ARC REVIEW CODE: R1909051

TO: Mayor Keisha Lance Bottoms, City of Atlanta
ATTN TO: Monique Forte, Urban Planner III, Department of City Planning
FROM: Douglas R. Hooker, Executive Director, ARC
RE: Development of Regional Impact (DRI) Review

Name of Proposal: Quarry Yards (DRI 2993)

TITLE: DRI SITE PLAN

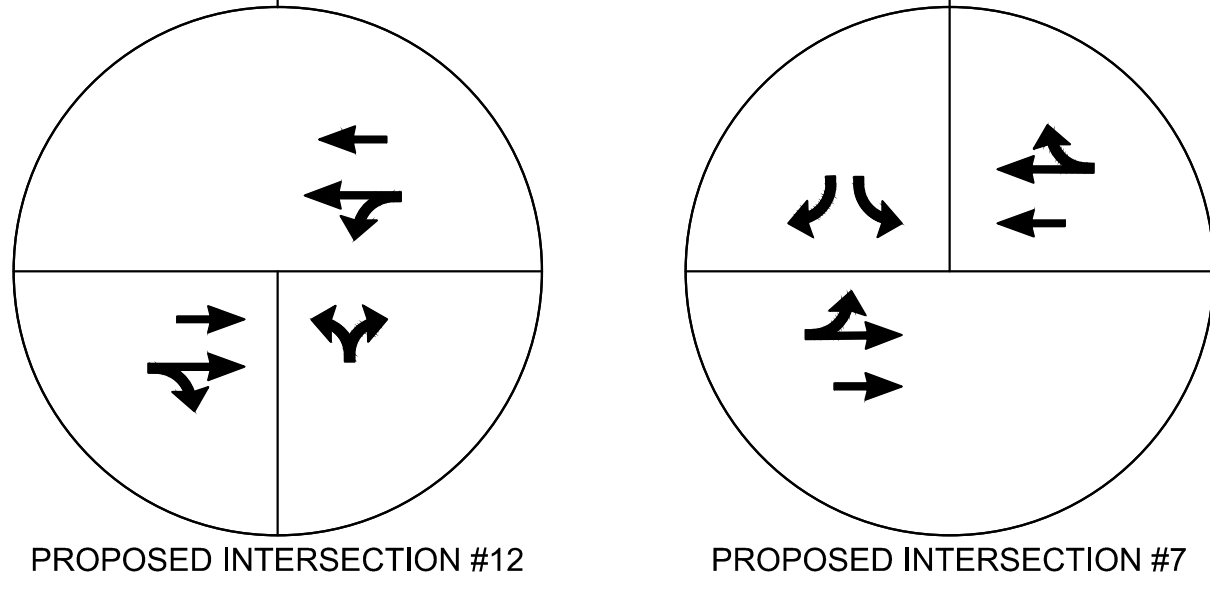
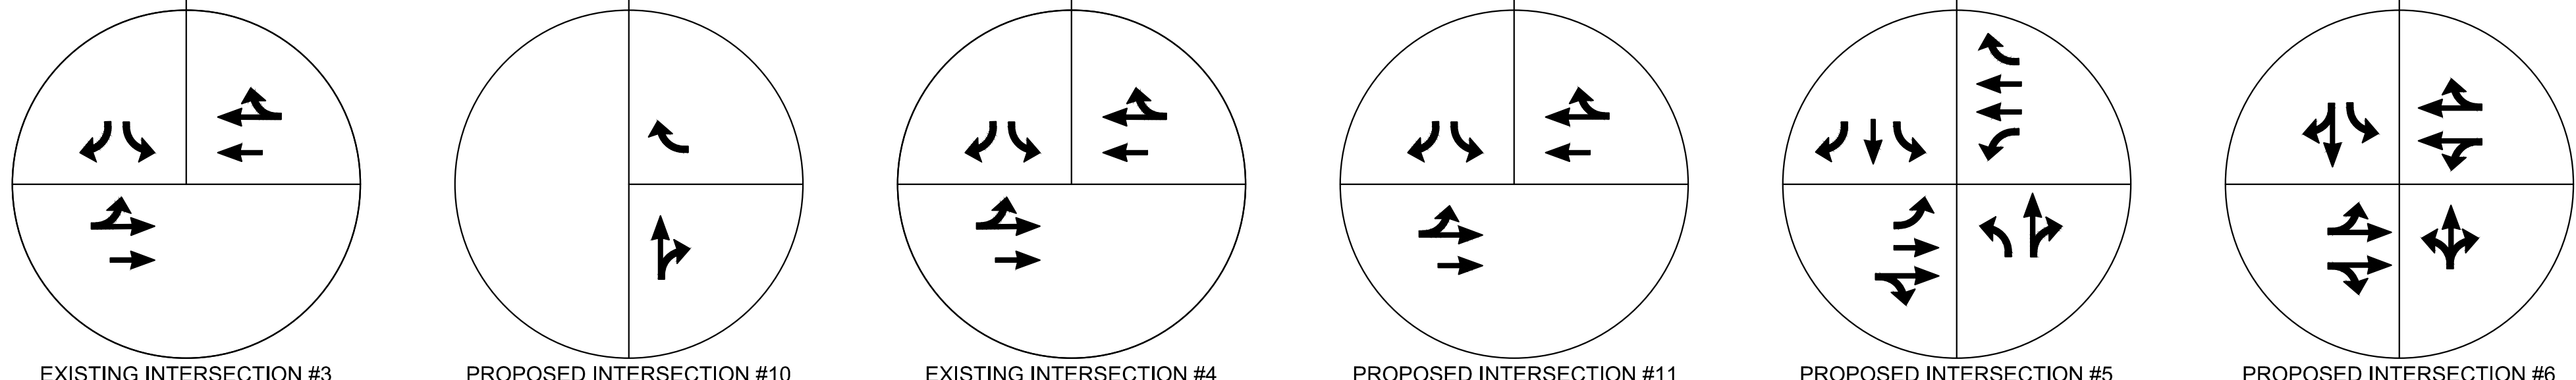
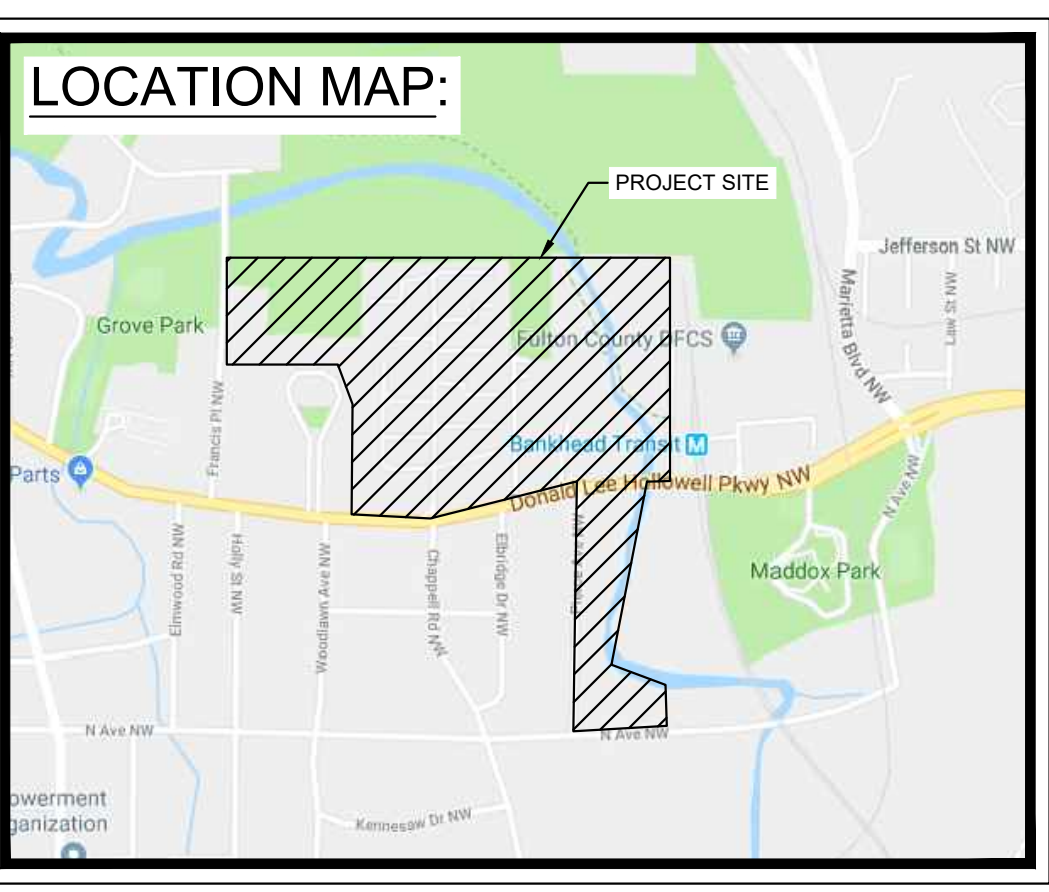
Just as important, the applicant team should ensure the installation of a robust, visible, protected crosswalk facility to safely move pedestrians and cyclists between the affordable multifamily area south of D.L. Hollowell Pkwy. (east of Pierce Ave.) and the main part of the development on the north side of the Parkway. The development team is also encouraged to ensure that end-of-trip facilities (bicycle racks or storage facilities, showers and lockers for workers, etc.) are provided at key locations throughout the site. Finally, the applicant team and other planning partners should revisit the concept of connecting to the planned Westside Reservoir Park as strongly as possible. This is especially true for the central and western sections of the site since the eastern area of the site has fairly direct access via the existing PATH trail and Gary Avenue. ARC staff's recollection of early concept plans for the Quarry Yards project included a pedestrian connection to the park and PATH trail from the northern extent of Elbridge Drive in the central area of the site, but such a connection is not shown on the submitted DRI site plan.

- As mentioned above, ARC transportation staff comments point out that the submitted site plan does not provide a clear picture of the location and design of bike or pedestrian facilities (e.g., bike lanes, sidewalks, crosswalks, etc.) internal to the site, including along internal roadways. Significantly more detail will be needed as this project moves through local review with the City of Atlanta. The City will also need to be clear on whether the internal roadways are to be dedicated as public streets or to become private streets.

The submitted site plan and the USGS coverage for the project area both show Proctor Creek running roughly south to north across the eastern side of the property. No other blue-line streams are shown on or near the project property on any coverage. The City 50-foot undisturbed stream buffer and additional 25-foot impervious setback (total depth of 75 feet) as well as the 25-foot State Sediment and Erosion Control Buffer are shown on both sides of Proctor Creek north of Donald Lee Hollowell Parkway, but not south of the road. The site plans show two proposed structures north of the Parkway intruding into the impervious setback and a pathway running along and crossing the creek. However, based on aerial photo evidence, the path already exists, and the proposed structures are on the sites of existing structures. Two new structures are shown near Proctor Creek south of the Parkway. If these structures intrude into the City stream buffers, variances may be necessary.

The site plan shows proposed driveways providing accessibility however no details on pedestrian facilities internal to the site are provided. The analysis does note pedestrian facilities are currently along roadways adjacent to the development.

The site plan shows proposed local road connectivity and existing pedestrian facilities along adjacent roadways. Details on whether pedestrian facilities are proposed internally are not provided on the site plan or in the analysis.
